Access Compliance Report

Public Rights-of-Way

(Curb Ramps)

Intersection ID: 15201	Main Street: ALBEMARLE_RD	Cross Street: LAWYERS_RD	Location: SW
ADA ID: 464EF1DA1C4F	Ramp Type: BlendTrans1	Initial Pass/Fail: Pass	Overall Compliance: No
Severity Score: 10			
Codes/Mitigation Info/Possible Solution		Field Measurements/Component Compliance

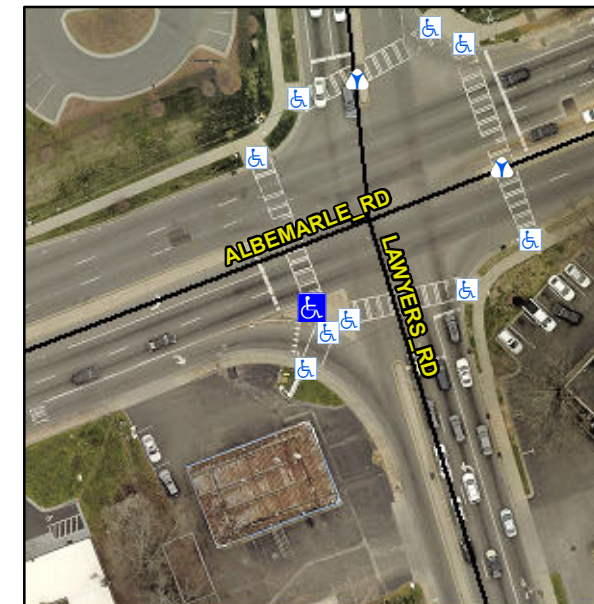
NO CURB LINE, LNDG SLOPE IS NEGATIVE

R304.2.2-Perp, R304.3.2-Para, R304.2.3, R302.7.2

Remove & Replace Curb Ramp With Two New Directional Ramps or Equivalent. Grind Gutter Lip.
